Safety Recall: Second Row (Both Outer) Seats

Supersedes 16-108, dated July 29, 2017, to revise the information highlighted in **yellow**

A16-108 REVISION SUMMARY

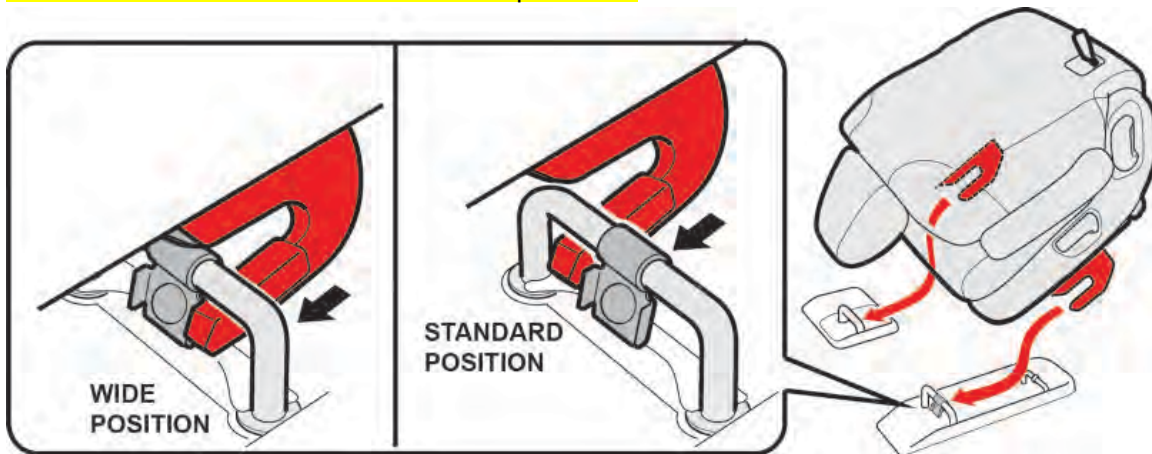
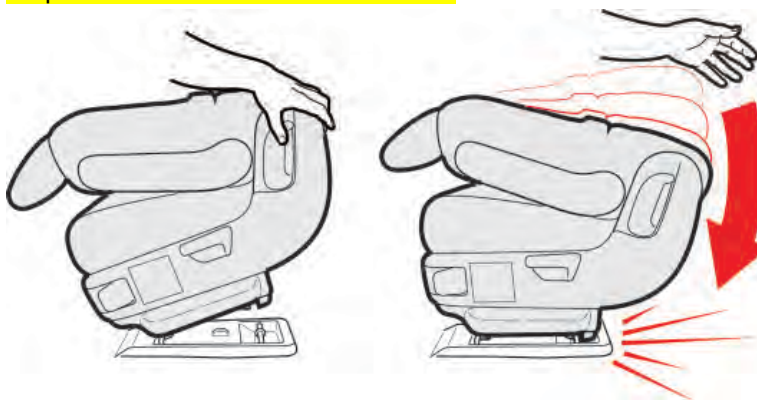
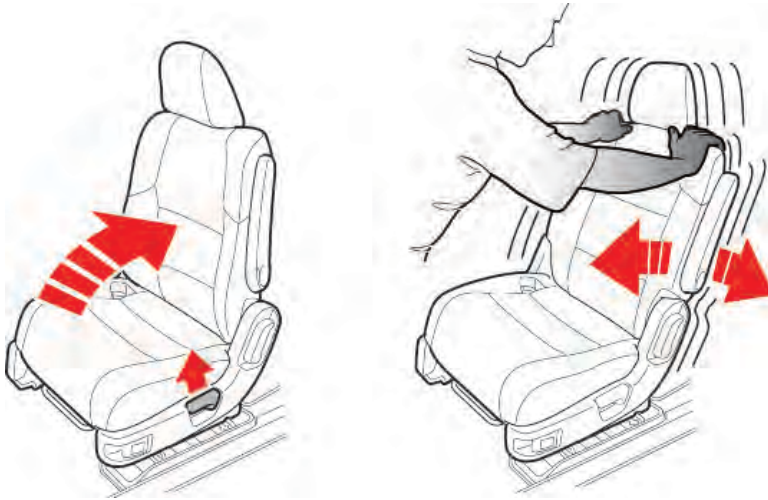
Some steps were changed in **REPAIR PROCEDURE**.

10.1. **With the seat-back folded down and adjusted to the rearmost position, insert the hooks into the floor strikers with the outer hook in the standard or wide position. .**

10.2. **After confirming both front hooks are fully inserted into the front strikers, begin to lower the seat then allow it to drop and lock to the rear floor strikers.**
